Access Compliance Report

Public Rights-of-Way

Intersection ID: N/A	Main Street: CALDWELL_RD	Cross Street: SUNBURST_LN	Location: E
ADA ID: 457E2F22CCF5	Ramp Type: PerpDiag	Initial Pass/Fail: Fail	Overall Compliance: No
		Severity Score: 10

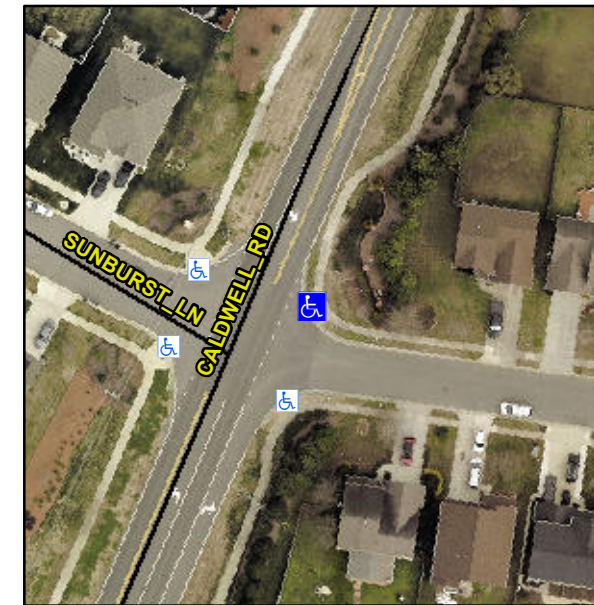
R304.5.1, R304.5.3

Compliance	Description	Data	Compliance	Description	Data
N/A	Ramp Length (in)	48.0	Yes	Ramp Slope (%)	6.1
No	Ramp Width (in)	42.5	No	Ramp XSlope (%)	2.3
N/A	Flare Type LT	N/A	N/A	Flare Type RT	N/A
N/A	Flare Slope LT (%)	N/A	N/A	Flare Slope RT (%)	N/A
N/A	Flare Traversable LT?	N/A	N/A	Flare Traversable RT?	N/A
N/A	Landing Length (in)	N/A	N/A	DWS Provided?	N/A
N/A	Landing Width (in)	N/A	N/A	DWS Contrast?	N/A
N/A	Landing Slope (%)	N/A	N/A	DWS Length (in)	N/A
N/A	Landing X Slope (%)	N/A	N/A	DWS Full Width?	N/A
N/A	Landing Curb? (Y/N)	N/A	N/A	DWS Offset (in)	N/A
N/A	Shared Landing?	N/A			
N/A	Gutter Ponding?	N/A	N/A	Gutter Slope (%)	N/A
N/A	Gutter Lip Ht (in)	N/A	N/A	Gutter X Slope (%)	N/A
N/A	Painted X Walk1?	No	N/A	Painted X Walk2?	No
	X Walk 1 Direction	To NW		X Walk 2 Direction	To SW
N/A	X Walk 1 Width (in)	N/A	N/A	X Walk 2 Width (in)	N/A
	X Walk 1 Slope (%)	4.5		X Walk 2 Slope (%)	3.4
	X Walk 1 X Slope (%)	3.4		X Walk 2 X Slope (%)	3.1

Remove & Replace Curb Ramp With Two New Directional Ramps or Equivalent.
